# UNITED STATES PATENT AND TRADEMARK OFFICE

APPLICATION NO.	FILING DATE	FIRST NAMED INVENTOR	ATTORNEY DOCKET NO.	CONFIRMATION NO.
09/783,375	02/14/2001	Douglas Michael Johnescu	BERG-2572/C2685	2317

**Office Action Summary**

*Attachment 1*

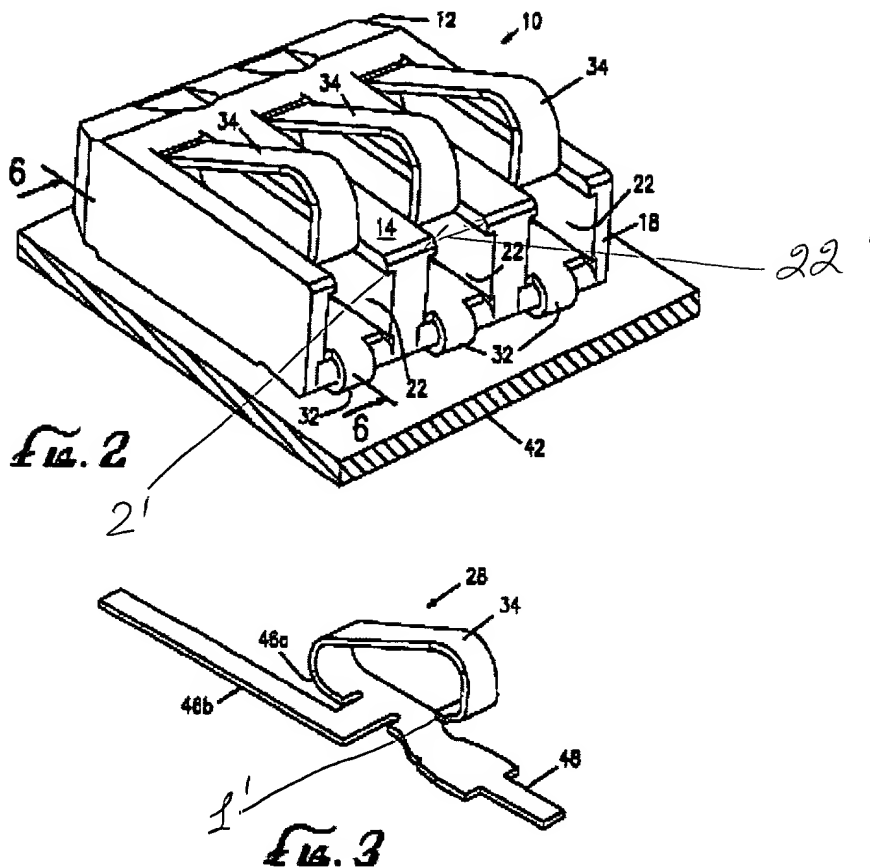
Kwait does not discuss the contacts preloaded but includes the structure that provides it, such as **ears** (1') on the distal end of a portion 34 and **shoulders** (2') on the top of the compartment 22 and top wall 14 (see Figs. 2 and 3 in the attachment 1).

**In regards to claim 32**, the contacts are compressed to insert a tab 34 into associated opening 22' in the housing formed by shoulders 2' (see Figs. 2 and 3 of <sup>attached drawing)</sup> ~~an attachment~~ 4):

Kwait does not discuss the contacts preloaded but includes the structure that provides it, such as **tabs** (1') on the distal end of portion 34 and **shoulders** (2') on the top of the compartment 22 and top wall 14 (see Figs. 2 and 3 in the attachment 1).

**In regard to claim 19**, the housing comprises a retention structure 2' (see attachment 1, Fig. 2).

**In regard to claim 20**, each contact 28 includes a medial section (not labeled, an area abuts a wall 16), a mounting portion 32, and a compressive mating portion 34 having a distal end, wherein the retention structure 2' (see attachment 1) engages the distal ends (not labeled, lower part of mating portion 34) to preload the contacts (see Figs. 1 and 2).
